1978 Corvette: Service Bulletin: Removable Roof Panel Fit

Source: Chevrolet Dealer Service Technical Bulletin

Bulletin No: 78-T-23

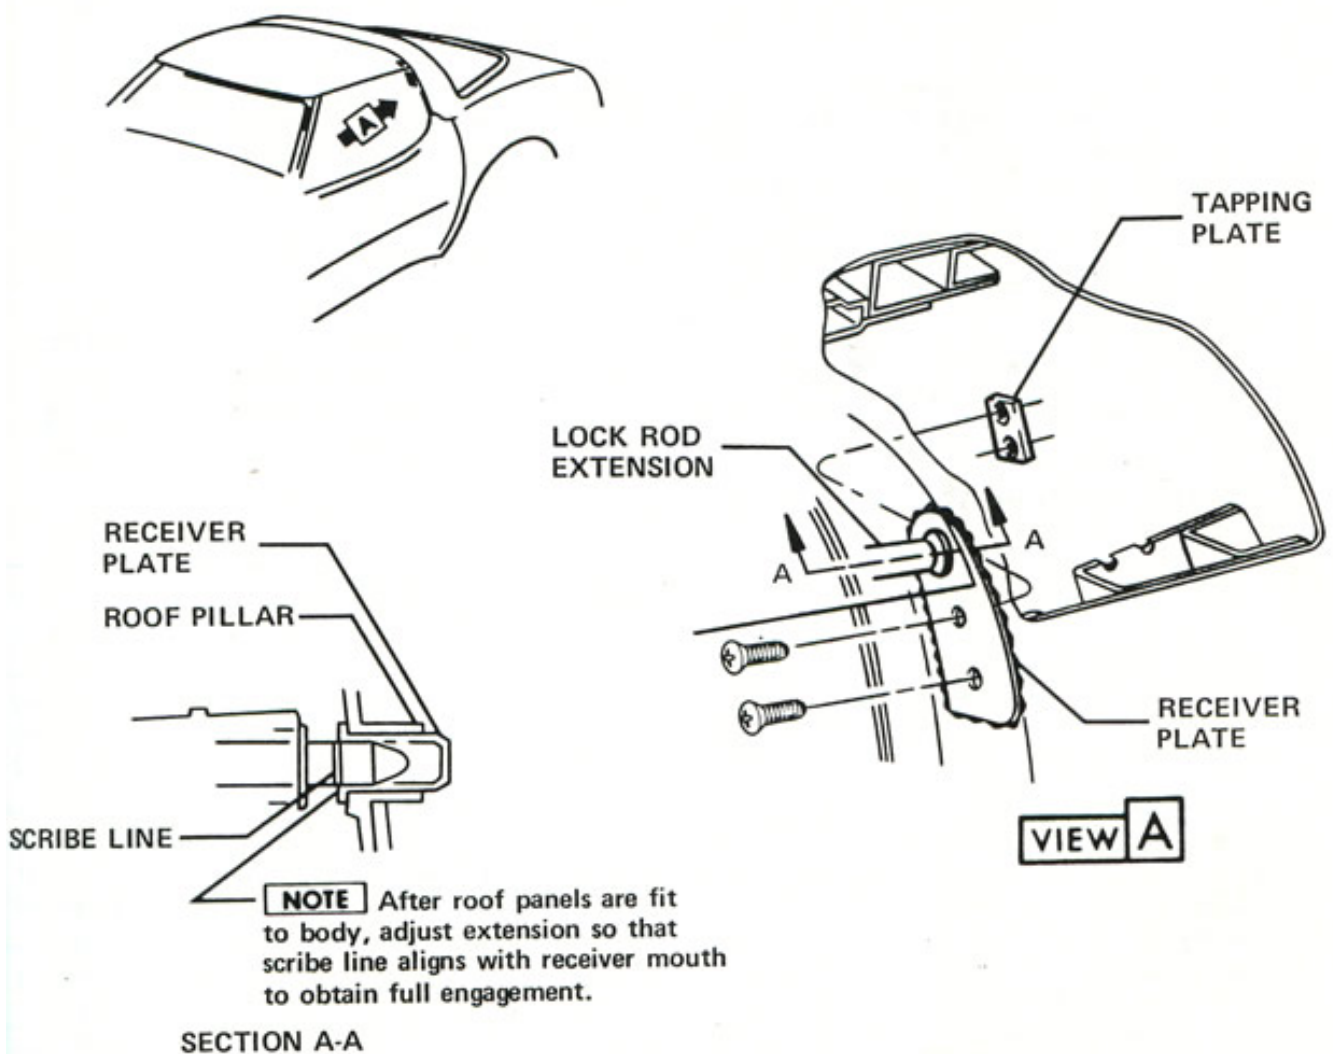
Some early 1978 Corvette removable roof panels may be bowed in relation to the windshield header and/or rear roof. This condition can be caused by an improperly positioned roof lock receiver plate.

The bow in a roof panel can be eliminated by lowering the roof lock receiver plate as outlined below:

1. Remove the rear roof corner garnish and lower roof trim panel.
NOTE: It is not necessary to remove the shoulder belt or retractor.
2. Remove the roof lock receiver plate screws. Hold the tapping plate, located behind the roof pillar, to prevent it from falling (see illustration on page 2). Remove any excess sealer from pillar and receiver plate.
3. Using a small round file, elongate (lower) the three holes in the roof pillar as required to obtain a relaxed roof panel with a flush fit. This will be a trial and error process of installing the receiver plate and checking that the roof panel lock rod extension engages easily.

4. When an acceptable roof panel fit is achieved, thoroughly pack the area behind the receiver plate with 3M Strip-calk or equivalent.
5. Reinstall interior trim panels.
6. Adjust the door glass to the roof weatherstrip as described in Section 2D, 1978 Service Manual.
